METROPOLITAN GOVERNMENT OF NASHVILLE AND DAVIDSON COUNTY

Metropolitan Historic Zoning Commission
Sunnyside in Sevier Park
3000 Granny White Pike
Nashville, Tennessee 37204
Telephone: (615) 862-7970
Fax: (615) 862-7974

STAFF RECOMMENDATION 503 Coffee Street April 15, 2015

Application: New construction—addition and outbuilding
District: Salemtown Neighborhood Conservation Zoning Overlay
Council District: 19
Map and Parcel Number: 08108026700
Applicant: Martin L. Espinosa
Project Lead: Melissa Baldock, melissa.baldock@nashville.gov

Figures 1 & 2. 503 Coffee Street

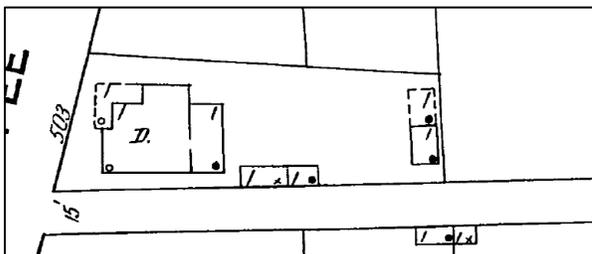
Background: 503 Coffee Street is a single-family house constructed prior to 1914 (Figures 1 & 2). It appears on the 1914 Sanborn map (Figure 3).

ELEVATIONS		
Project number	Project Number	A105
Date	Issue Date	
Drawn by	Author	
Checked by	Checker	
Scale		1/8" = 1'-0"

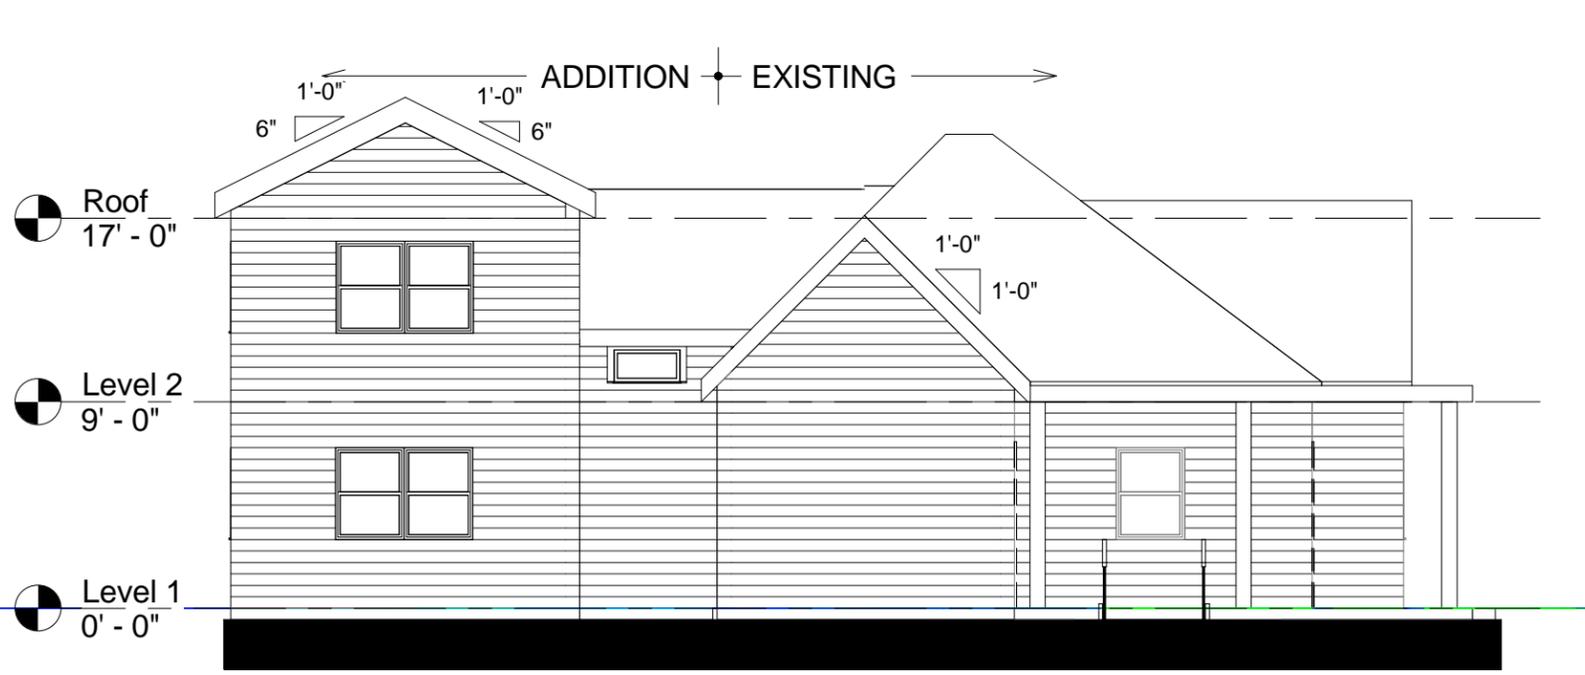
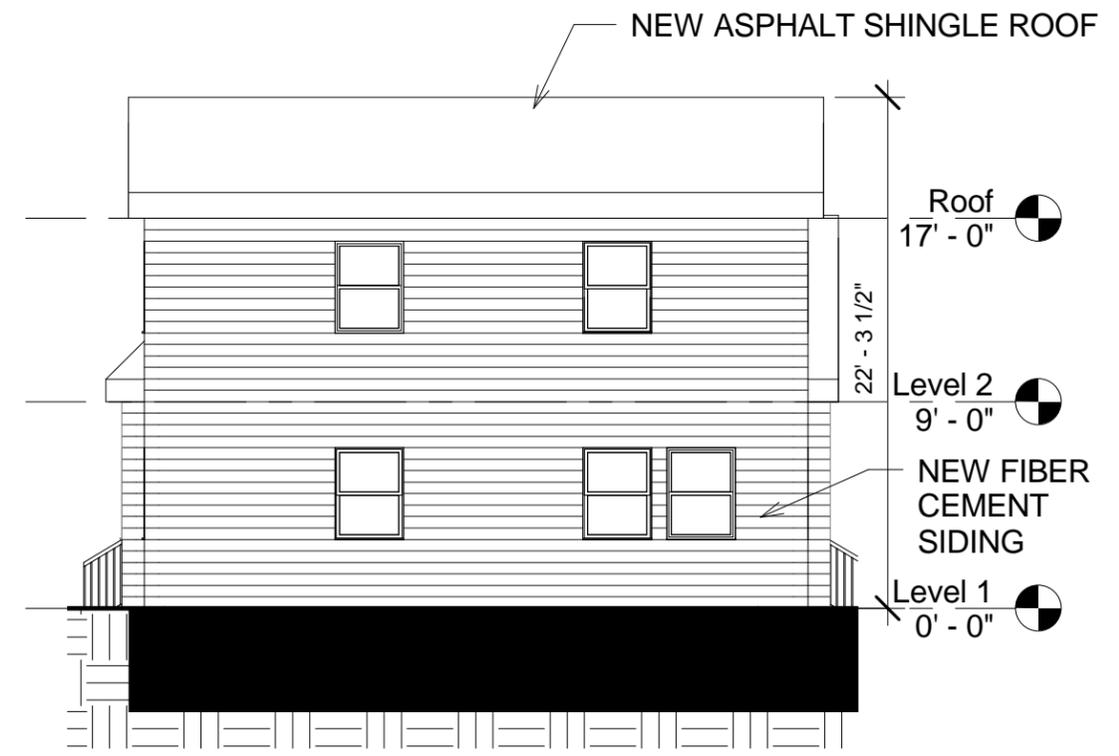
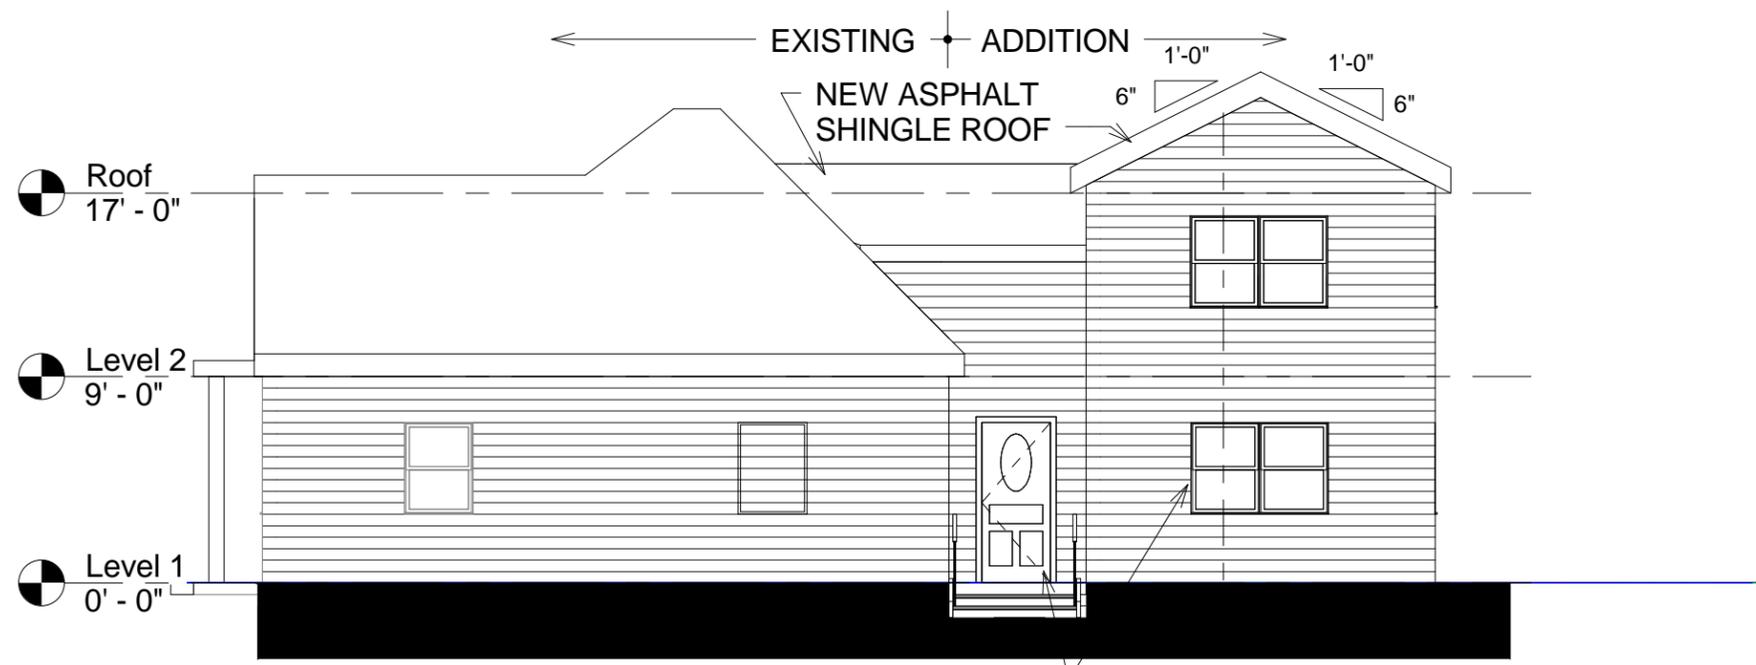
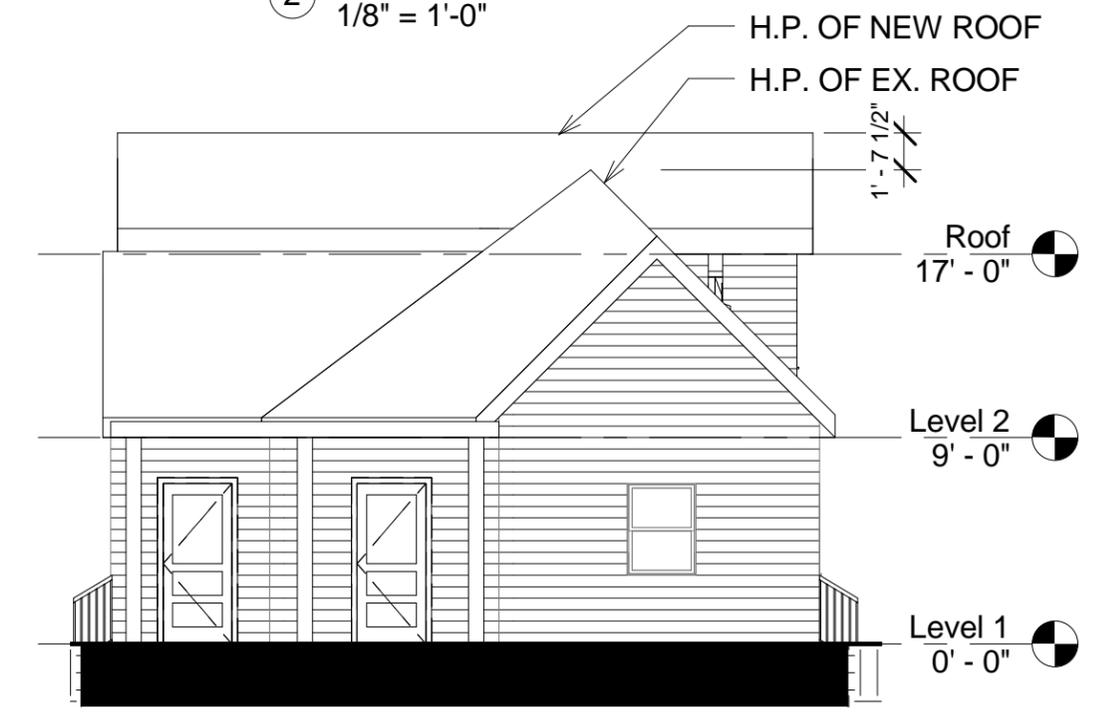
A portion of the addition will be two stories in height behind the one-story house. The addition will rise in height to be four feet (4') taller than the historic house. The taller portion of the house will not occur until over forty feet (40') behind the front of the house, reducing its impact on the historic house. Its roof will be side gabled, reducing its visibility from the front.

Roof form: The existing house has a multi-part roof with gabled and hipped elements. The roof pitches range from 10/12 to 12/12. The addition will tie into the historic house with a 4/12 gable. The taller portion of the addition will have a side gable form with a 6/12 pitch. Staff finds that the project's roof forms meet Sections III.E. and IV. of the design guidelines.

Staff finds that the addition's height and scale meet Sections III.A., III.B., and IV. of the design guidelines.

GARAGE ELEVATIONS

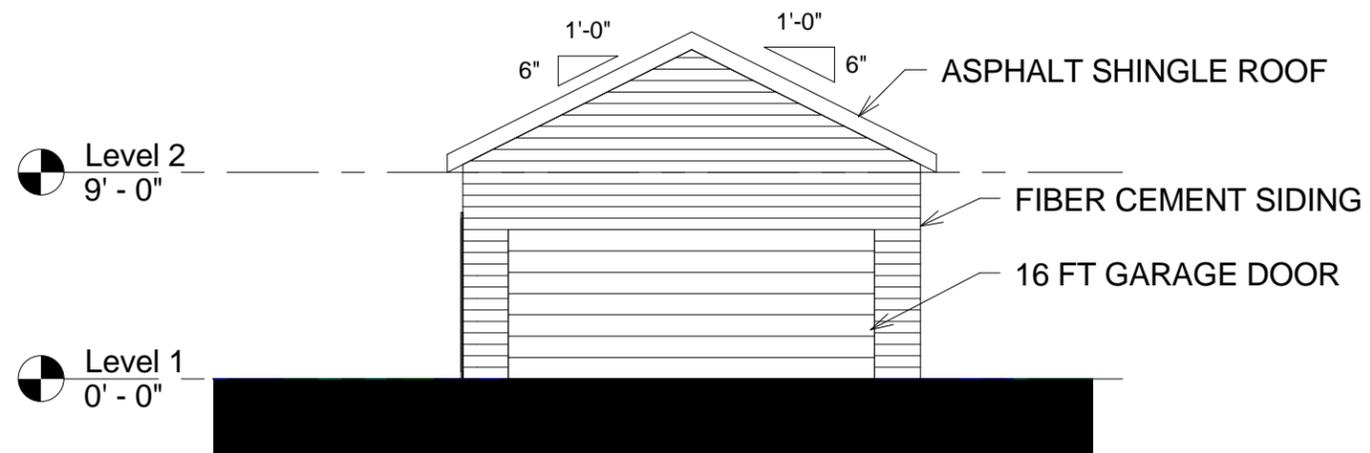
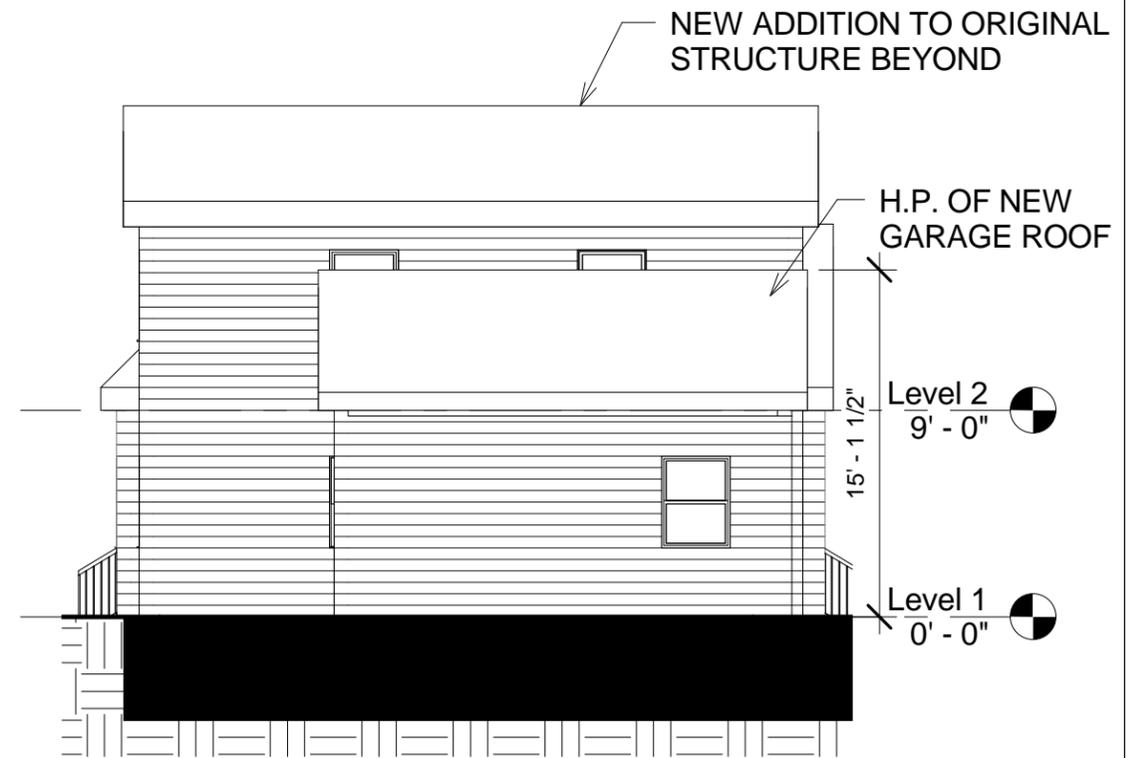
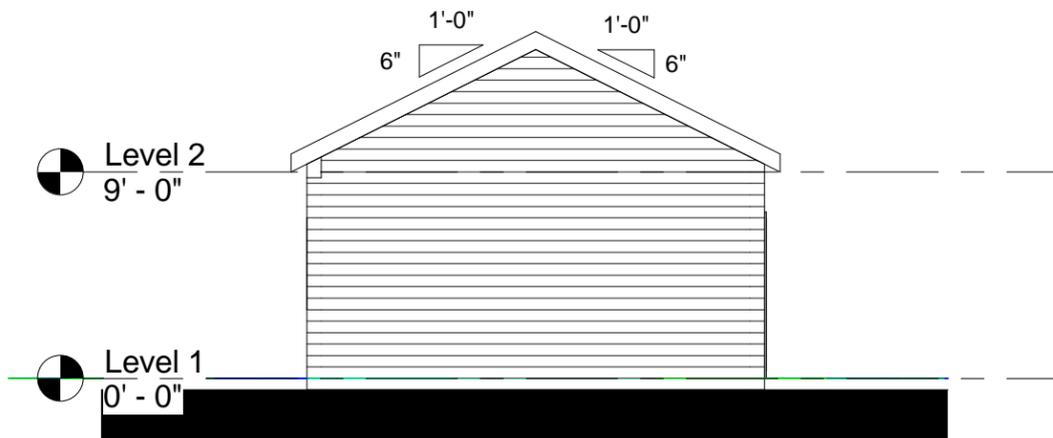
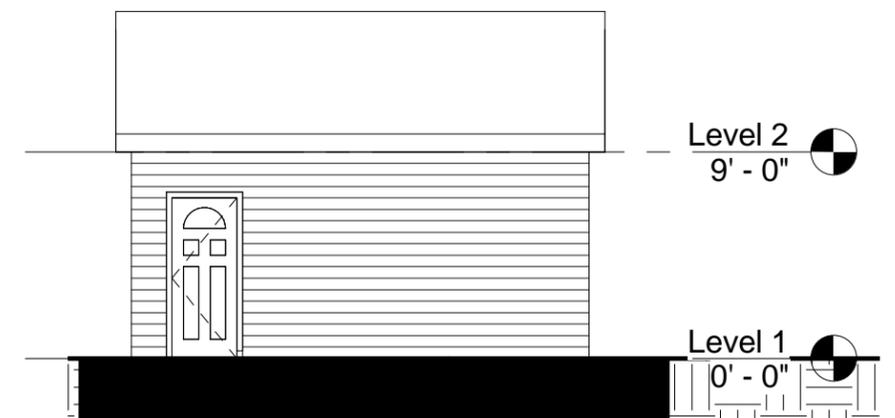
Outbuildings: The applicant is proposing a one-story, two car outbuilding, that will not be used as a dwelling unit. See attached "Outbuilding and DADU Worksheet" for the specifics as to how the outbuilding meets the design guidelines. The materials for the outbuilding will match that of the addition – cement fiberboard lap siding, asphalt shingle, and a concrete slab for the foundation. Staff will need to approve all final material choices for the outbuilding. Staff finds that the proposed outbuilding meets Section III.H. of the design guidelines.

DEMOLITION PLAN		D101
Project number	Project Number	
Date	Issue Date	
Drawn by	Author	
Checked by	Checker	Scale 1/8" = 1'-0"

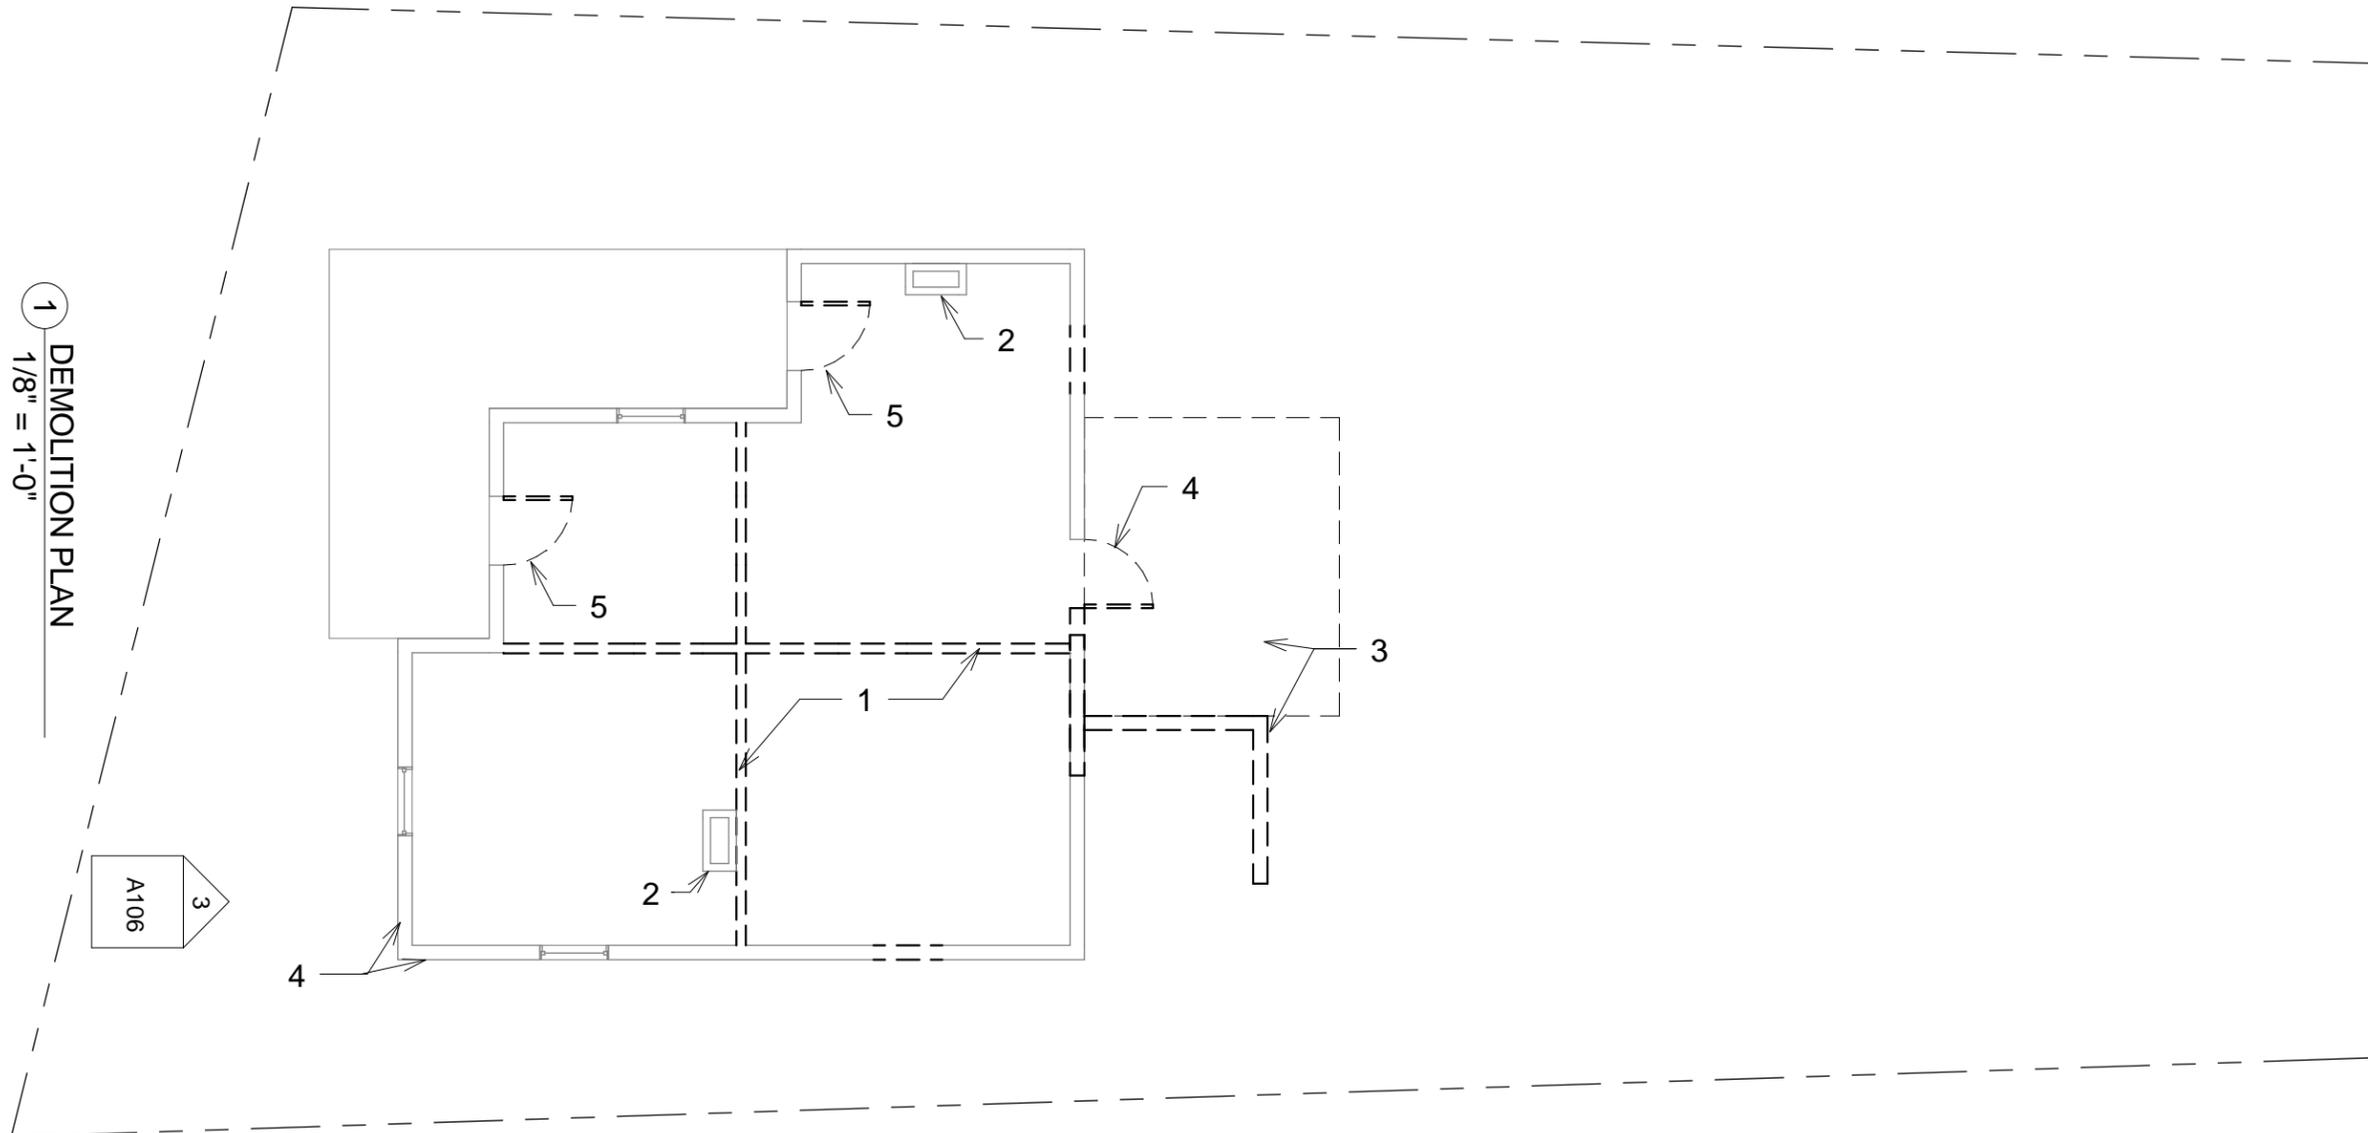
Partial Demolition: The applicant is proposing to remove an existing rear porch addition (Figure 6). The rear porch does not seem to have the same footprint as the addition that appears on the historic Sanborn maps. Its roof form, architectural details, and placement at the rear of the structure do not contribute to the historic character of the historic house nor the Salemtown neighborhood.

The applicant also plans to alter one historic window opening on the right elevation (Figure 7). Staff finds the alteration of this window opening to be appropriate because it is located on the back half of the house, and the change will not adversely affect the historic character of the house.

Staff therefore finds that the removal of the existing rear addition and the alteration of the window opening on the right facade meet Section V.B.2 for appropriate demolition and do not meet section V.B.1 for inappropriate demolition.
